COLORADO DIVISION OF RECLAMATION, MINING AND SAFETY MINERALS PROGRAM INSPECTION REPORT

MINE NAME:	MINE/PROSPECTING ID#:	MINERAL: COUNTY:	
Hitch Rack Ranch	P-2014-016	Granite, granite gneis El Paso	
INSPECTION TYPE:	INSPECTOR(S):	INSP. DATE: INSP. TIME	Ξ:
Monitoring	Timothy A. Cazier	April 12, 2016 15:30	
OPERATOR:	OPERATOR REPRESENTATIVE:	TYPE OF OPERATION:	
Transit Mix Concrete Co.	Jerry Schnabel	ME - Mineral Exploration

Photo 3. Common Mullein on B-1 Drill Road.

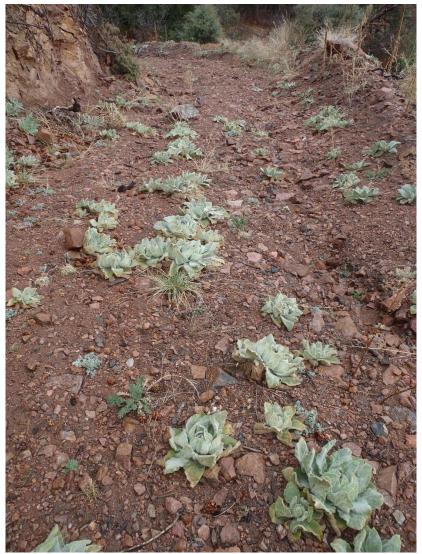
PROBLEM/POSSIBLE VIOLATION: Problem: There are state-listed noxious weeds (notably common mullein) present on site. This is a problem for failure to employ weed control methods for state listed noxious weed species within the permitted area, and to reduce the spread of weeds to nearby areas as required by Section 3.1.10 (6) of the rule.

Revegetation is proposed for the drill pads and new roads, but had not been initiated at the time of the inspection. A significant number of new common mullein were observed on this drill road (see **Photo 3**). The amount of mullein observed is cited as a problem on page 1 of this report.

CORRECTIVE ACTIONS: The prospector shall develop a weed control and management plan in accordance with Section 3.1.10 (6) of the Rule. This plan should be developed in consultation with the county extension agency, or weed control district office and should include specific control measures to be applied, a schedule for when control measures will be applied and a post-treatment monitoring plan. This weed control plan shall be submitted to the Division as an NOI Modification to the approved plan with the appropriate NOI Modification fee of \$108.00 by the corrective action date.
